Technical Service Bulletin

TSB1416 CX65 CDI unit

June 3, 2016

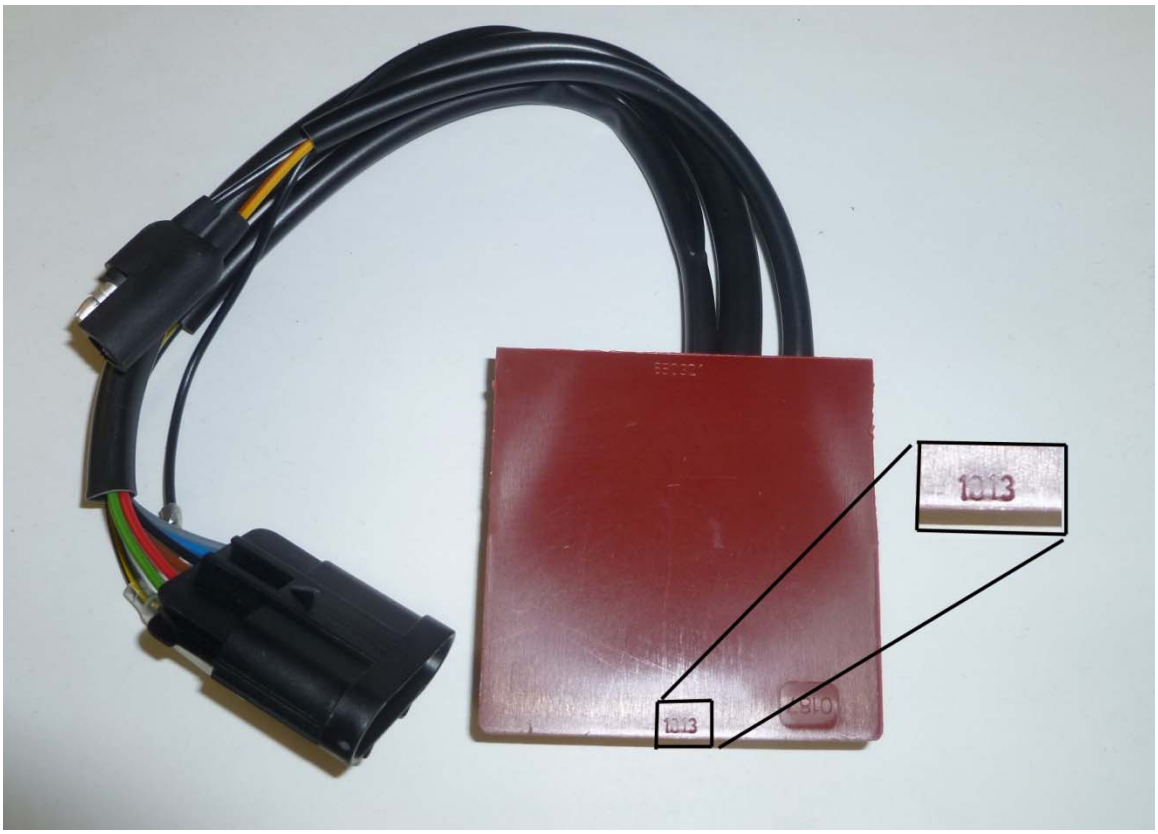
There is a new CDI unit for the Power Valve CX65 has improved ignition values that improve the 'over rev'. From this time forward this new box will be considered the standard service replacement for all CX65 power valve bikes from 2012 on.

This CDI box can only be identified by the date code. It will have a date code of "0116" (January 2016) or later as identified in the location shown in the picture below. (The picture below shows a date code of 1013 or October 2013)
